**AGENDA**  
**PLANNING AND ZONING COMMISSION MEETING**  
**CITY OF CREVE COEUR, MISSOURI**  
**MONDAY, FEBRUARY 3, 2020**  
**6:30 PM**

**UNFINISHED BUSINESS****1. Applications #19-046 & #19-047: Approval of a Boundary Adjustment and a Site Development Plan for a 20 Unit Apartment Building at 10809-10819 Olive Boulevard**

**APPLICATION TO PLANNING AND ZONING COMMISSION  
#19-046 & #19-047: APPROVAL OF A BOUNDARY ADJUSTMENT AND  
A SITE DEVELOPMENT PLAN FOR A 20 UNIT APARTMENT BUILDING  
AT 10809-10819 OLIVE BOULEVARD**

**Figure 9: Fire Vehicle Tracking**

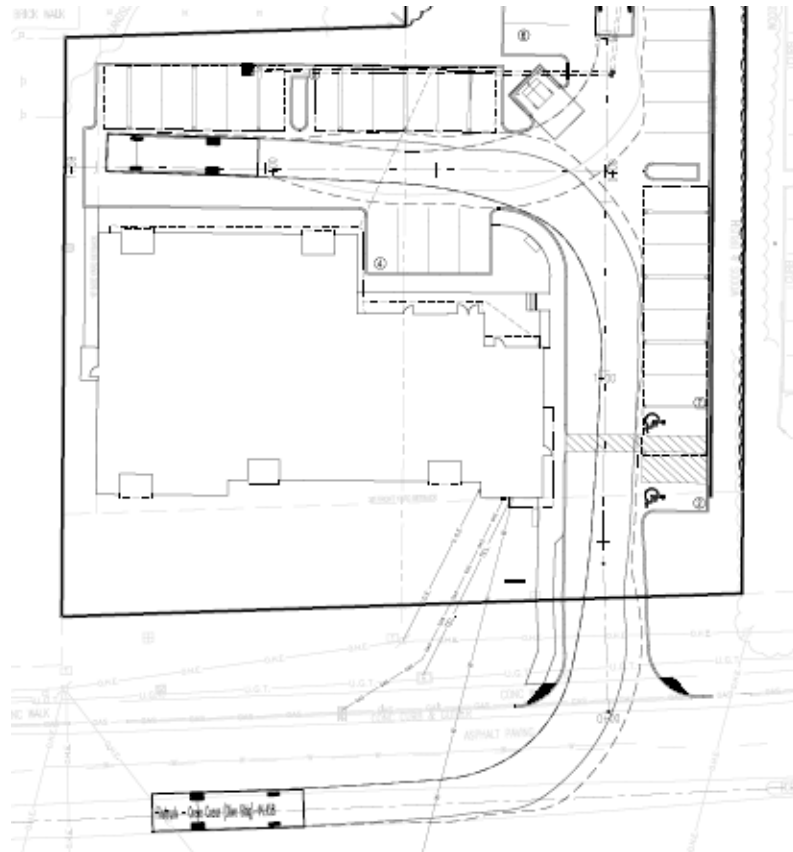
The Applicants have provided a drawing showing fire truck vehicular movement. While it appears very tight, it does show that the turn movements can be made. The Creve Coeur Fire District will be required to review and provide final approval for access and radius.

Figure 8: Cloe-up of the Site Consolidation Plat.

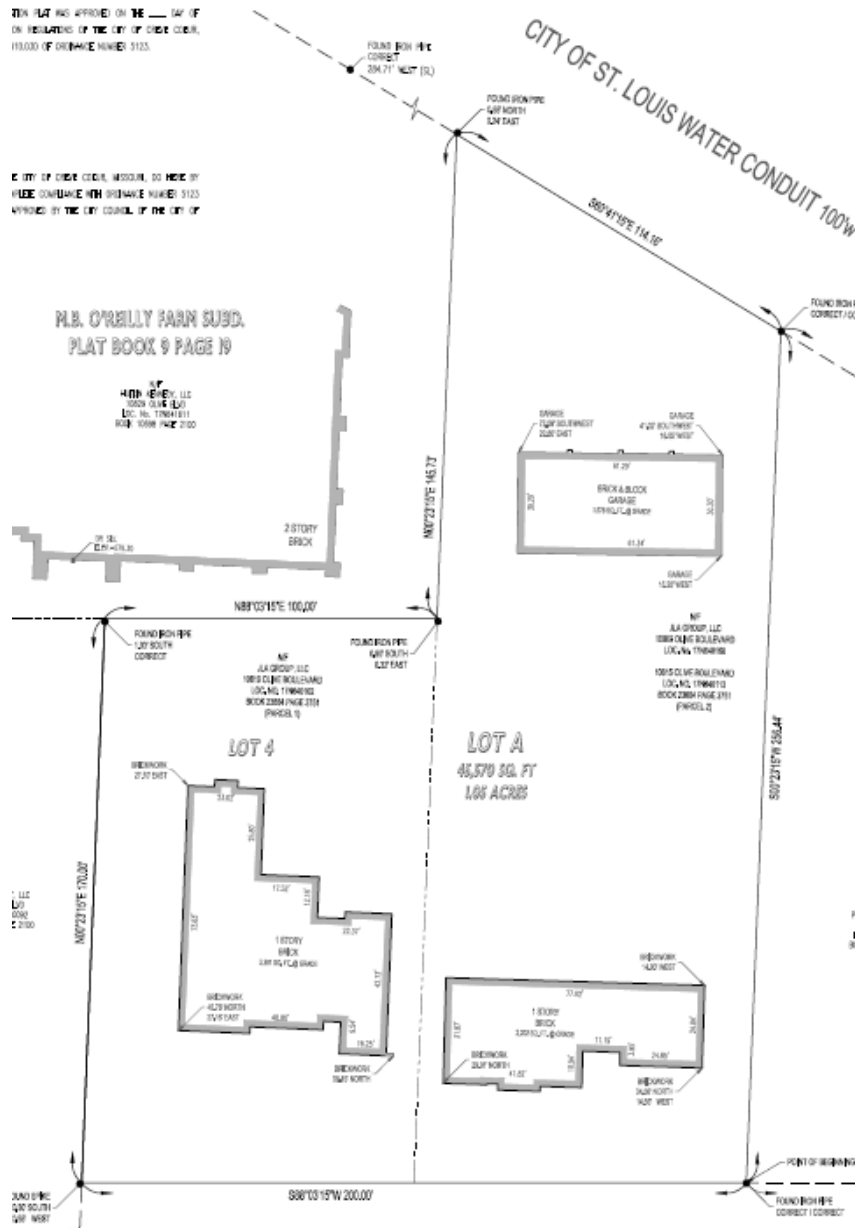
As discussed in the prior staff report. The proposal includes a site consolidation plat to consolidate the two lots into one of 1.05 Acres.

Figure 6: Close-up of the site plan where greater pedestrian interest needs to be provided.

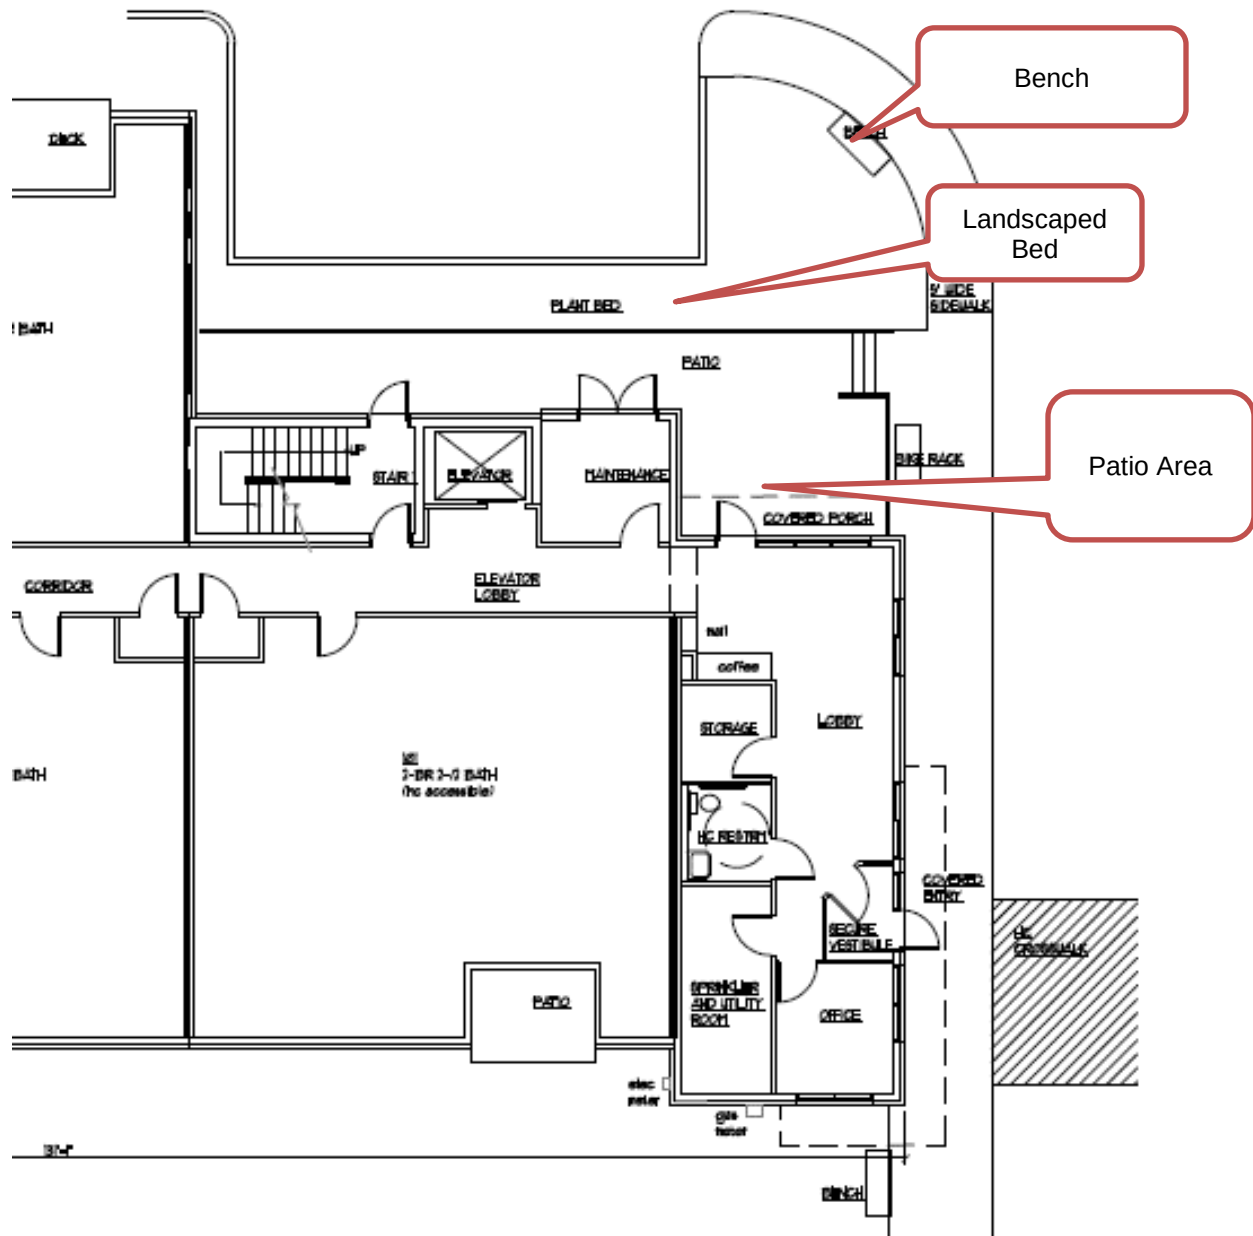
parking to the north elevation to the lobby/entrance need to provide better connections as opposed to just ending at the parking lot, and the placement of a single bench within the landscaping seems poorly placed. A better integrated outdoor amenity space in this area would elevate the overall design of the area.

**Figure 7: Applicant's Carport and Trash Enclosure Elevations**

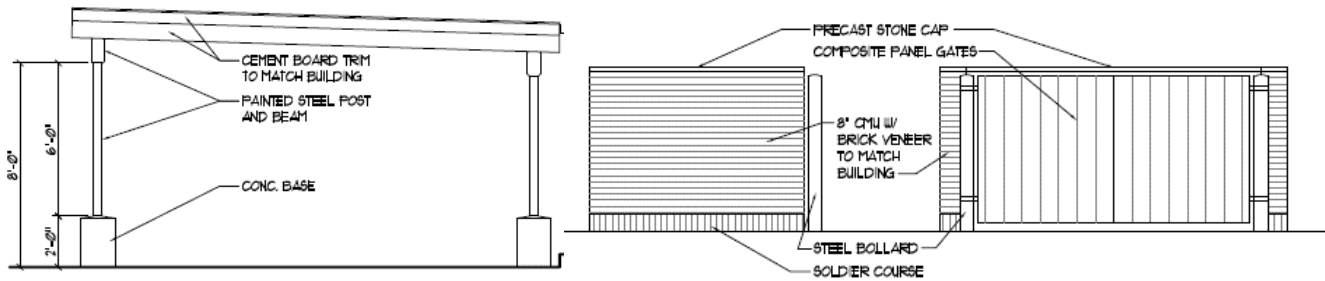
Additionally, the City's Design Guidelines strongly encourages high quality landscaping that accentuates the building and site. Accessory Buildings and Facilities are to be designed to directly relate in material, character and detail to the primary building on the site, as well as the design of fencing, sound walls, trash enclosures, and similar site elements is to be compatible with the architecture of the main buildings and should use similar materials. The Design Guidelines state that Multi-Family Developments shall provide underground parking or parking within a basement garage for at least 50% of the required vehicular parking (p. 13). This also cross references a prior Zoning Ordinance, for the conditional uses for multi-family developments which now states that at a minimum, seventy percent (70%) of the required vehicular parking shall be provided within a parking garage or structure that is aesthetically integrated into and incorporates architectural features of the principal structure. While the proposal is not a conditional use, and thus the 70% of parking within a parking garage is not required, the Applicants are providing 50% of the parking under carports, that are appropriately placed to the rear and side of the building, behind the front building line. However, the proposed carports lack the design consideration relating to the basic structure. Greater design consideration should be provided to the column, instead of the painted steel post and beams on a concrete base. As an alternative, Staff recommends that the posts be wrapped in a durable material similar to the building and have a darker tone to blend into the site, for a smoother appearance. An example of this recommendation is provided in Figure 8, below.

Figure 9: Close-up of the site plan showing the sidewalks with the sidewalk depth circled.

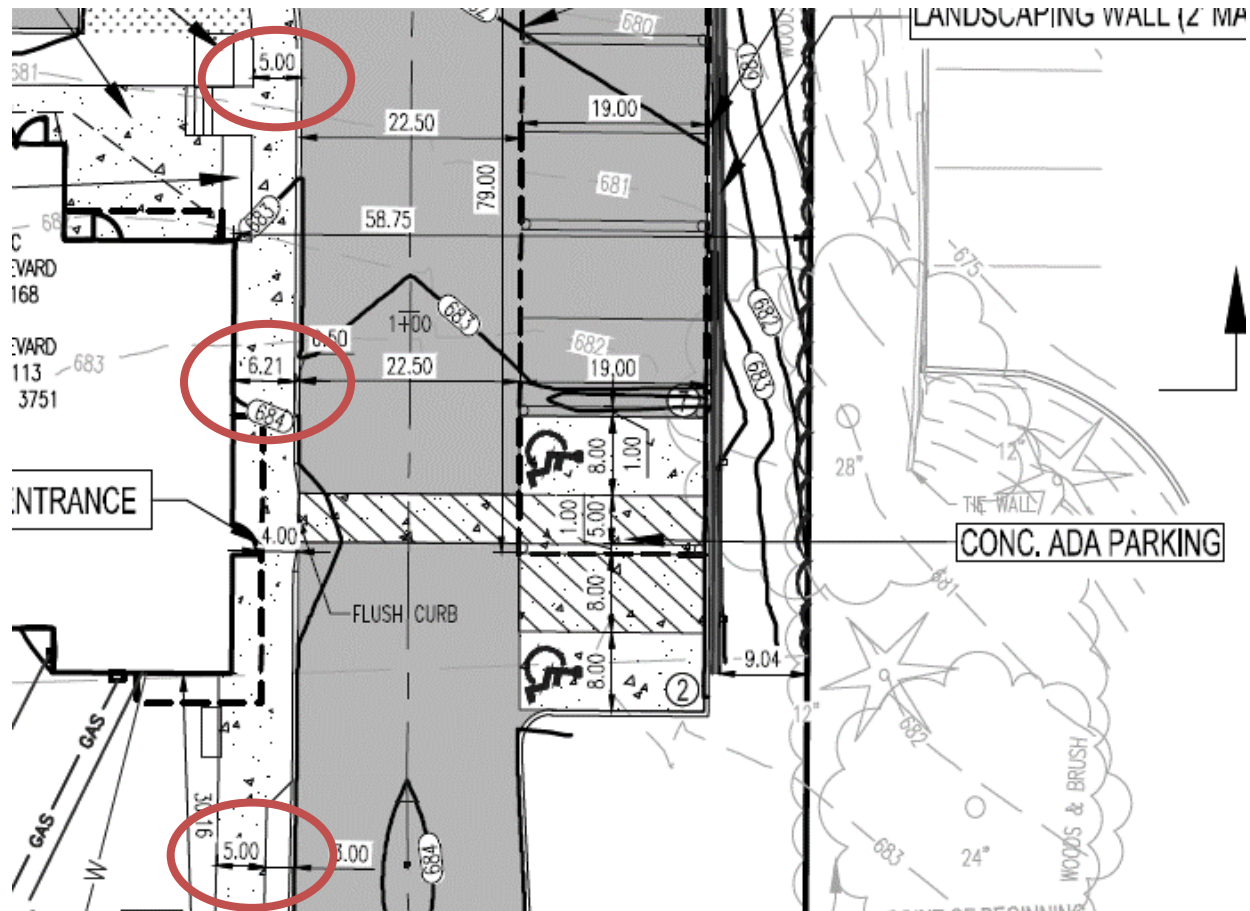
utilized where pedestrian circulation paths cross a vehicular route as determined by the Planning and Zoning Commission.

**Figure 10: Applicant's Site Consolidation Plat**

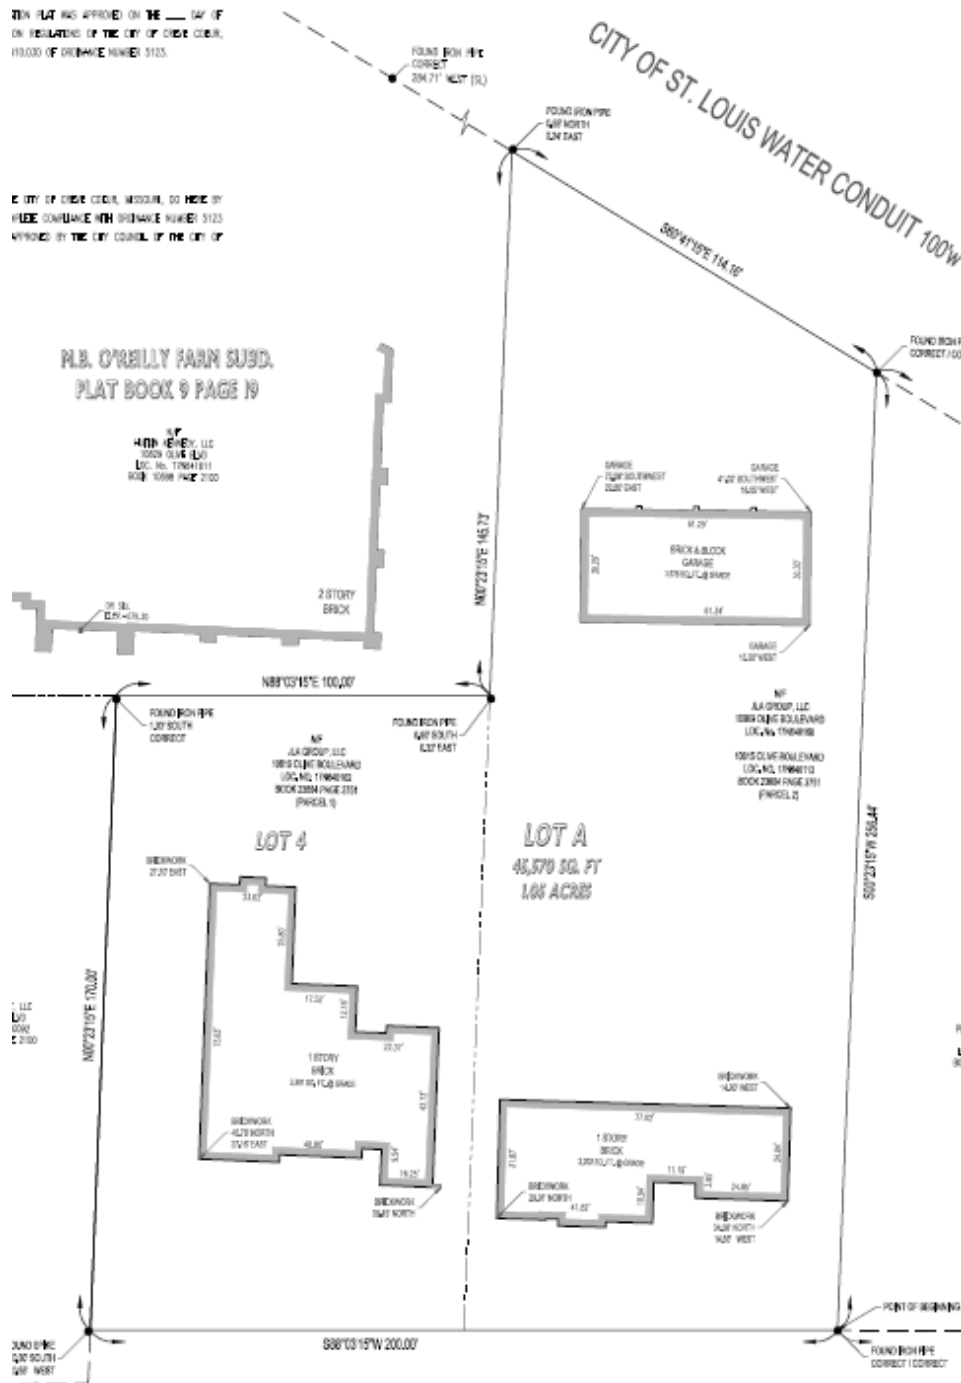
As discussed above, the proposal includes an application (Application #19-047) to consolidate the two lots into one 1.05 Acres.
